# Compliance Submittal

Project Name: KINGS RIDGE PUD PHASE IV

PROJECT NAME: Brighton @ Kings Ridge Phase III

RE: KINGS RIDGE CONSTRUCTION ENTRANCE  
(FBA 941216.035)

EXISTING CONSTRUCTION ENTRANCE

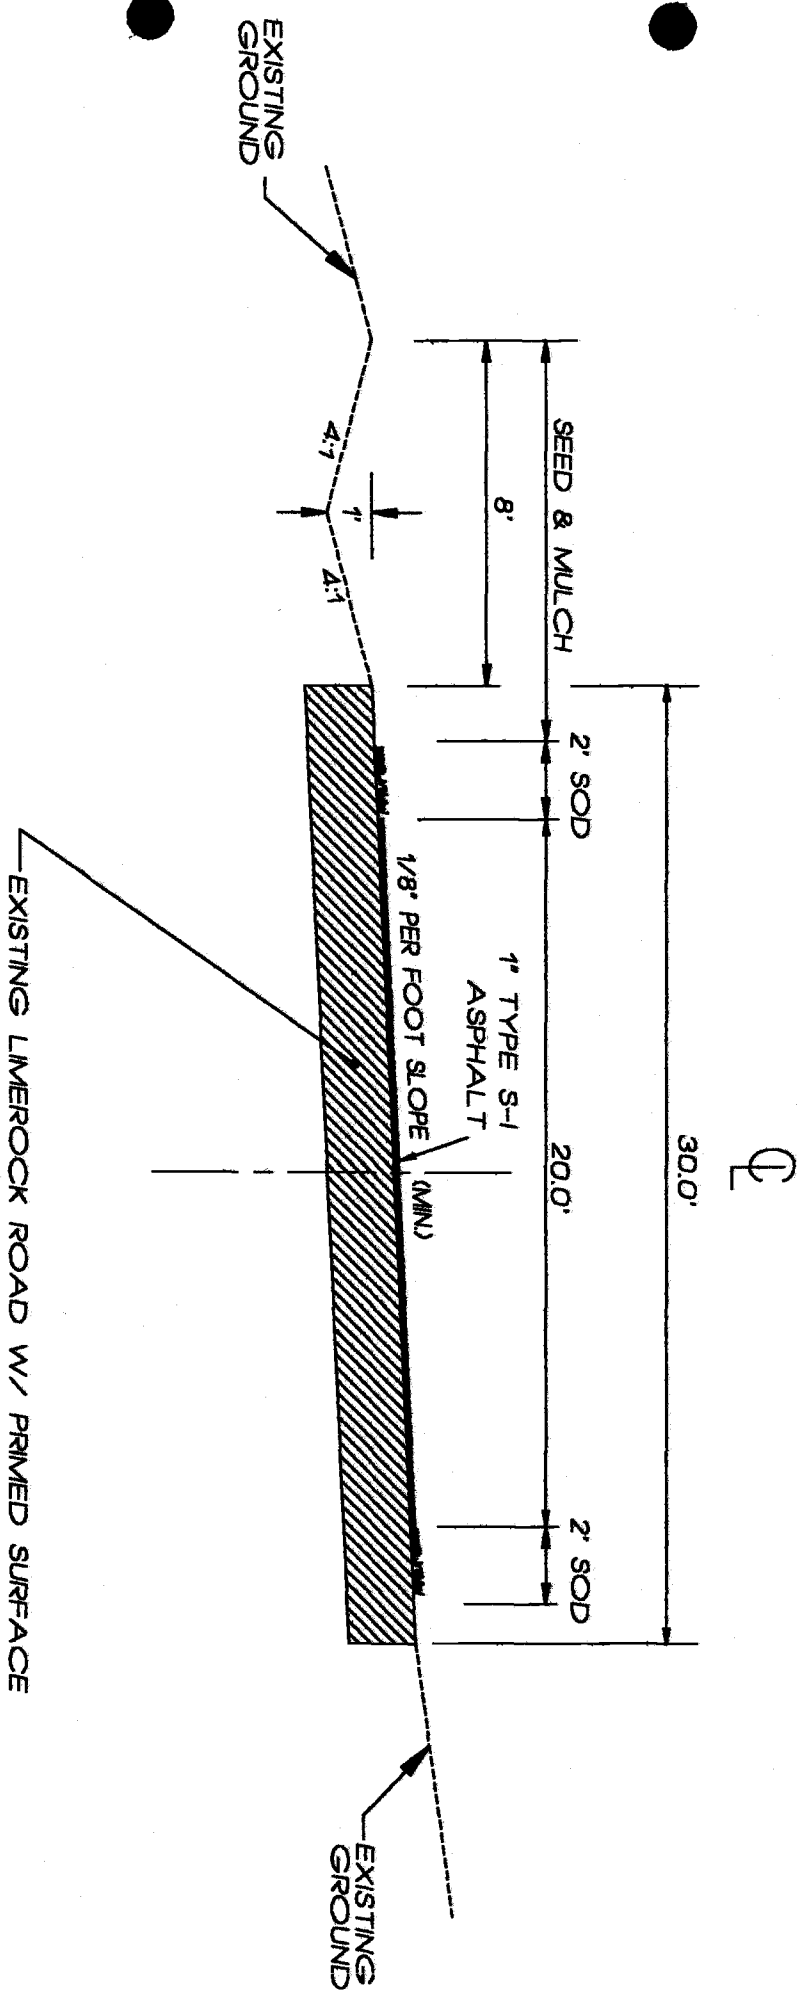
Pursuant to our telephone conversation please find attached an 8 1/2 x 11 sketch of the existing construction entrance that is proposed to be paved from U.S. Highway 27 to Chapel Hill Boulevard. This letter is a request to pave 20-feet of the existing 30-foot limerock road, approximately 3,240 linear feet.

Please note that shown on the sketch is an 8-foot swale 1-foot deep to be constructed on the northside of the proposed paving to control erosion as well as provide stormwater treatment. Should you have any questions with regards to our request, please feel free to contact our office.
